Grimes Planning and Zoning Commission

Planning and Zoning Commission October 3, 2023 @ 5:30 p.m. **In Person at Grimes Community Complex, 410 SE Main Street, Room 202**

1. Willow Hills North Plat 1 Final Plat
2. Hope Meadows Plat 1 Final Plat
3. 212 SE Main Street Rezone
4. 212 SE Main Street Site Plan

RE: Willow Hills Plat 1 Final Plat

FINAL PLAT COVER SHEET

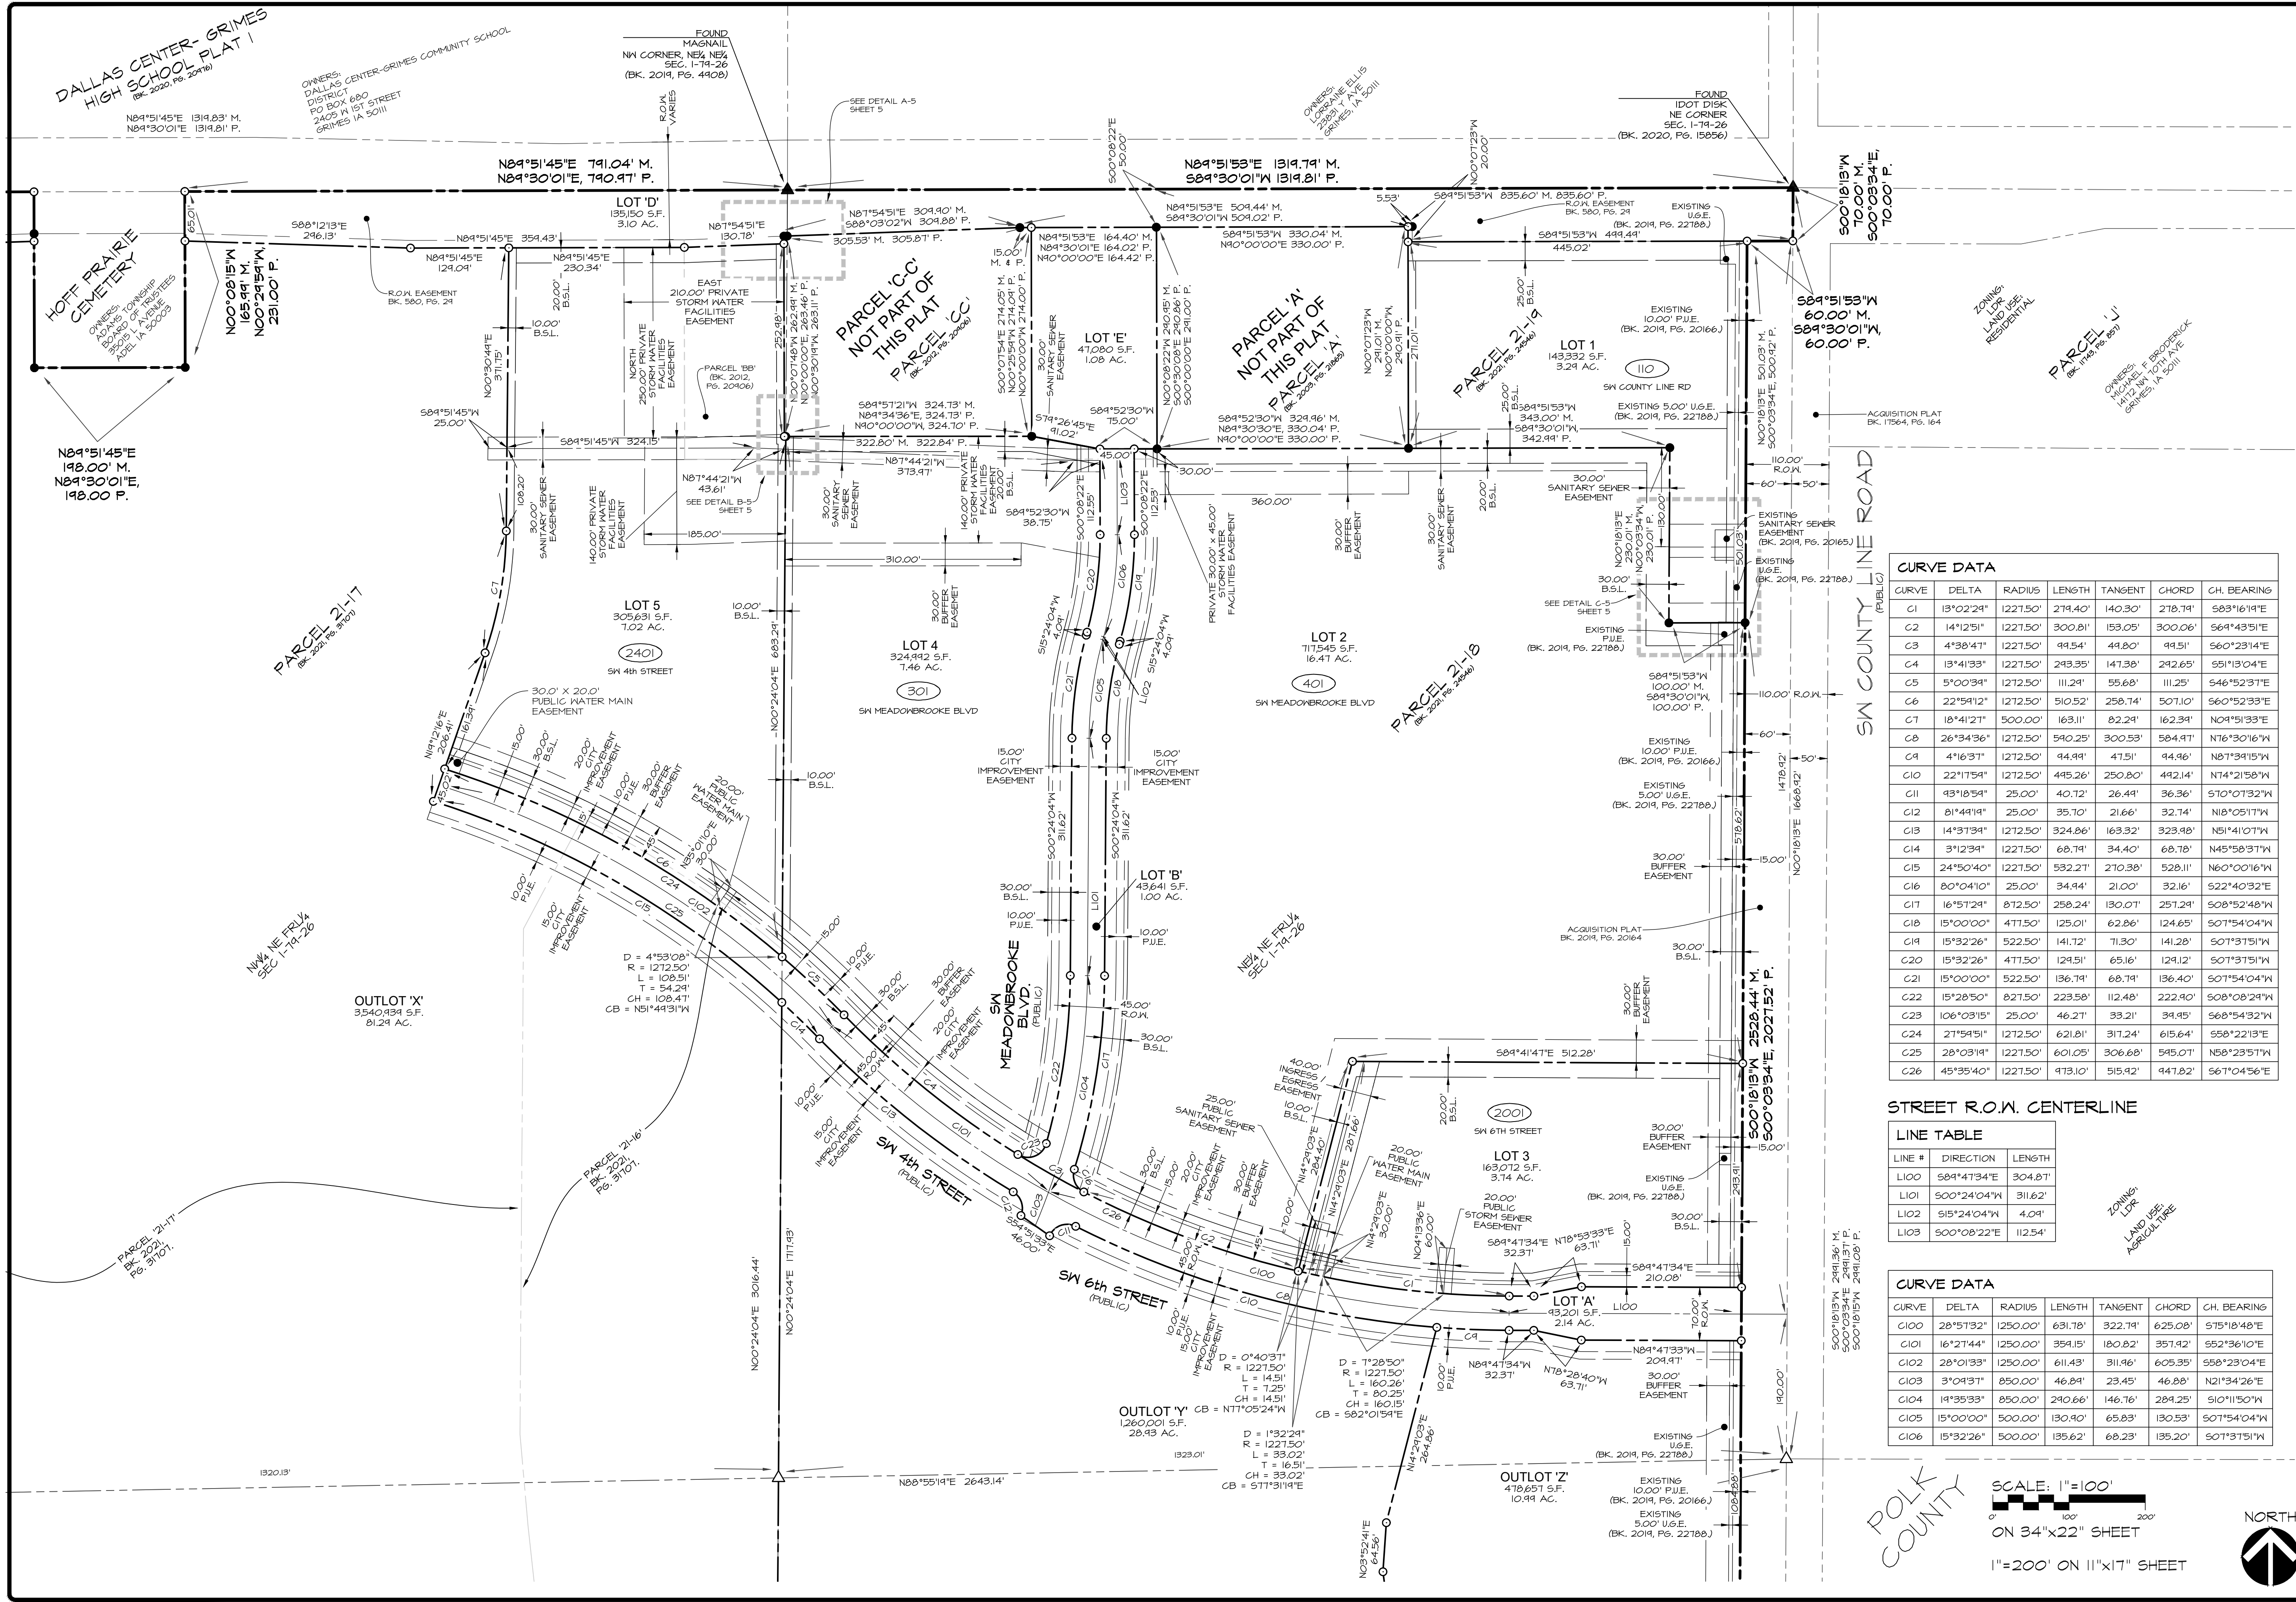
- ~~24. On Sheet 1, please update the zoning and setbacks per the Meadows PUD. Please add a reference to the Meadows Zoning Change and Development Agreement BK 2022 PG 16956.~~

- ~~a. Zoning Remove reference to C-1, R-2, R-3 Med and High.~~

~~b. Setbacks—Revise zoning categories to Single Family Residential, Townhome Residential, Multi-Family residential, Commercial to match PUD~~
